First Party Appeal to An Coimisiún Pleanála Report on Transport and Engineering

Proposed Aviation Related Cargo Handling Units at Huntstown,
Swords, Co Dublin

February 2026

Client Name: D. A. Terminal 3 Limited
Document Reference: 22-091r.021 ACP
Project Number: 22-091

PROPOSED SIGHTLINE PLAN
SCALE 1:5000

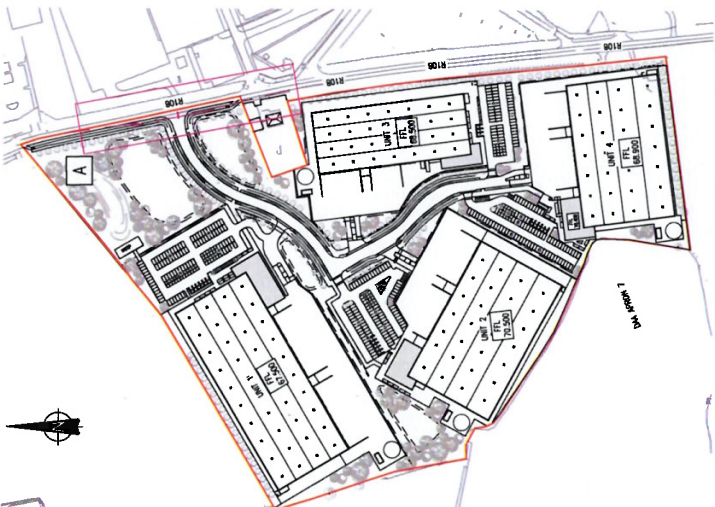
The applicant is requested to provide a revised sightline drawing demonstrating sightlines for a 60km/hr speed limit, as per the requirements of DN-GEO-03060 as published by Transport Infrastructure Ireland (TII); which is a minimum sightline of 90m visibility to the nearside edge of the road both sides of the entrance, viewed from a 2.4m setback from the edge of the road.

This drawing is included in Figure 5 and in Appendix A of this document shows clear and unobstructed sightlines in both directions at the location of the proposed access.

Drawing HT3-WAT-ZZ-XX-DR-P-01500 Rev - , Swept path of HGVs.

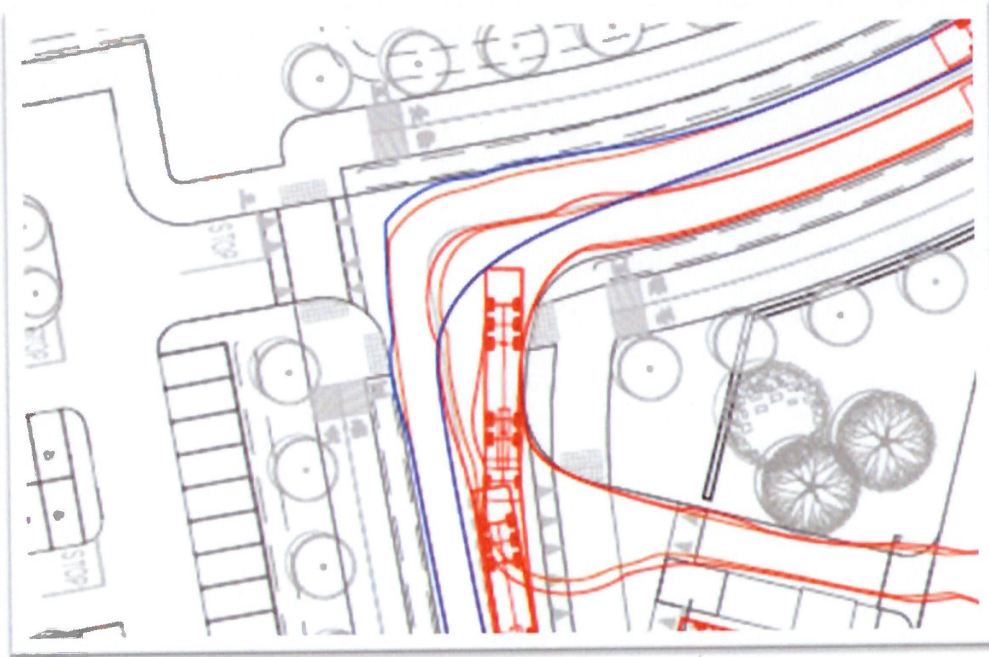
The swept path analysis shows that two heavy goods vehicles (HGVs) cannot pass on the spinal road at the tight horizontal radius bend adjacent to the car park access to Unit 2. Given the high number of vehicle movements anticipated at this location there is a risk that drivers will overrun the tactile paving and shared use pedestrian/cyclists area at the inside of the bend. This could lead to damage to the paving and hazards for those vulnerable road users.

Drawing HT3-WAT-ZZ-XX-DR-P-01500 Rev - , Swept path of HGVs.

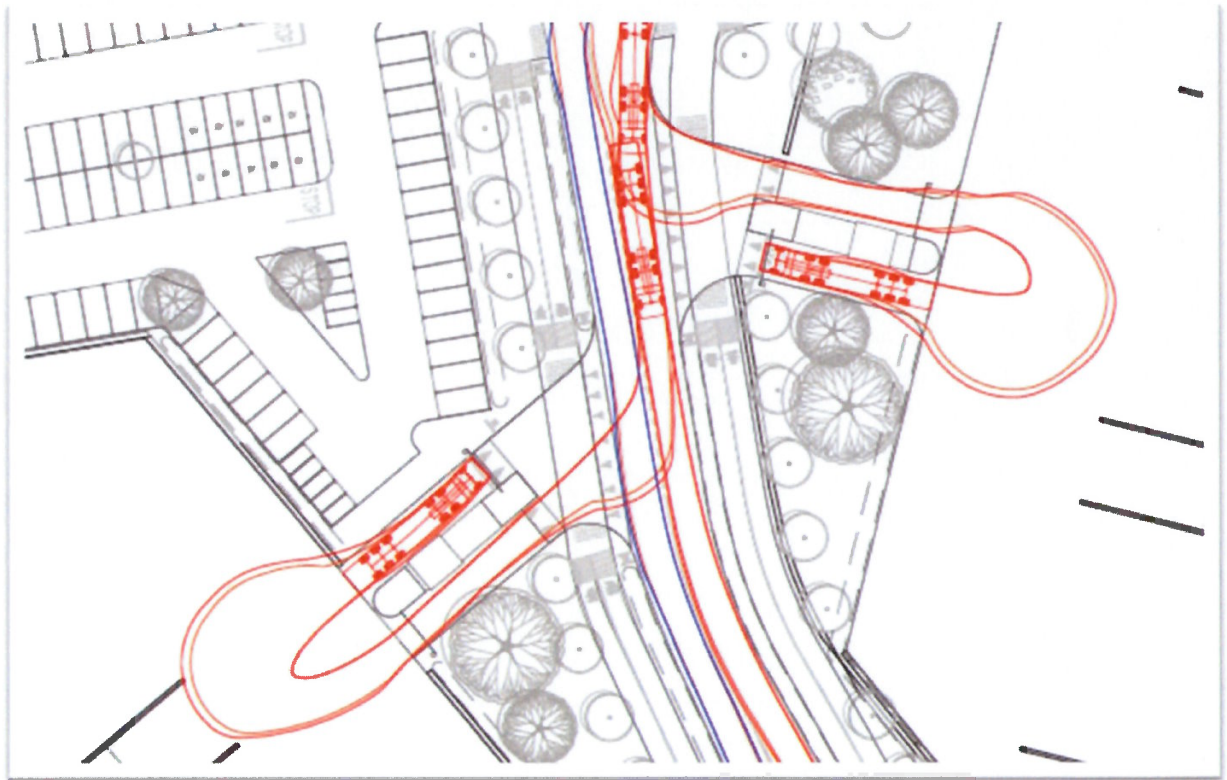
The swept path for HGVs entering Unit 2 has been shown on the drawings but not that for HGVs exiting. Given the tight corner radius this movement may lead to overrunning of the pedestrian/cyclist path resulting in hazards for those road users.

It is recommended that the swept path for exiting HGVs be carried out for Unit 2 and the other units to ensure the movement can be carried out comfortably.
